SP 2-423-001
SERVICE PROGRAM

The addition of a debris shield to the fuel management module (FMM) on certain model year 2014 and 2015 Xpeditors equipped with a factory installed FMM.

This Service Program provides information regarding the installation of a debris shield to the fuel management module (FMM).

Figure 1

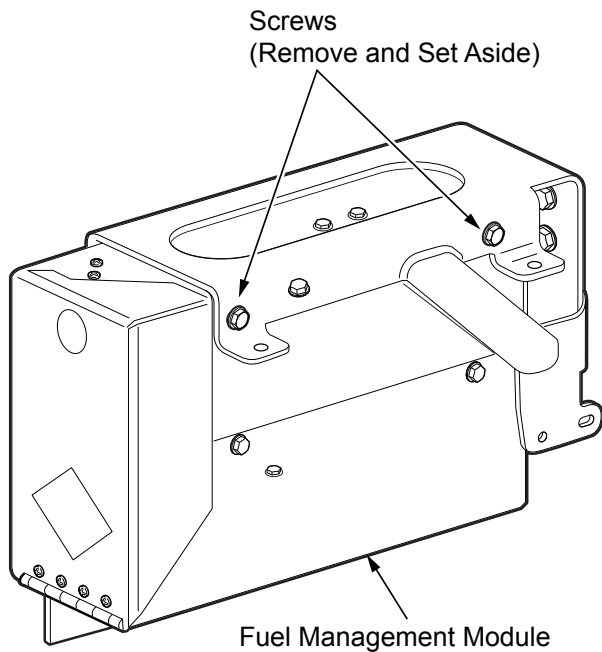
1. Locate the fuel management module (FMM) (see *Figure 1*).
2. Using the appropriate jack stand, support the fuel management module.
3. Remove the 2 mounting screws and set aside for reinstallation (see *Figure 1*).

Figure 2

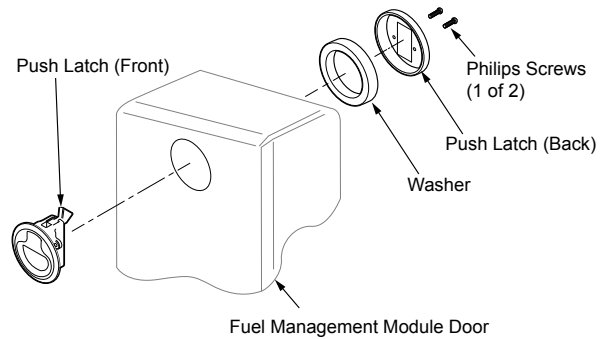
4. Pull down the fuel management module door, exposing the rear of the push latch. Using a #1 Philips screwdriver, remove the two screws and discard. Remove the back of the push latch and discard. Remove the washer and set aside for reinstallation. Remove the front of the push latch and discard (see *Figure 2*).

Figure 3

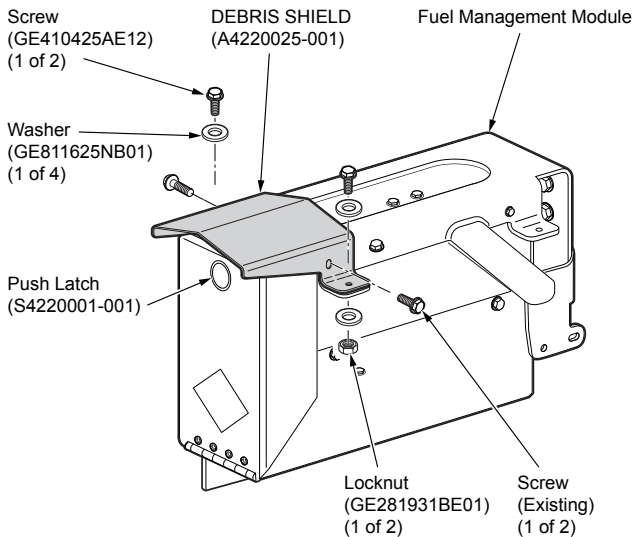
5. Utilizing the washer set aside in step 4, install the new push latch (S4220001-001) (see *Figure 3*).
6. Align the debris shield (A4220025-001) with the screw holes from step 3 and reinstall the 2 screws removed in step 3 (see *Figure 3*).
7. Install 2 screws (GE410425AE12) with 2 washers (GE811625NB01) and 2 locknuts (GE281925BK01) with 2 washers (GE811625NB01) to both sides of the debris shield (see *Figure 3*).
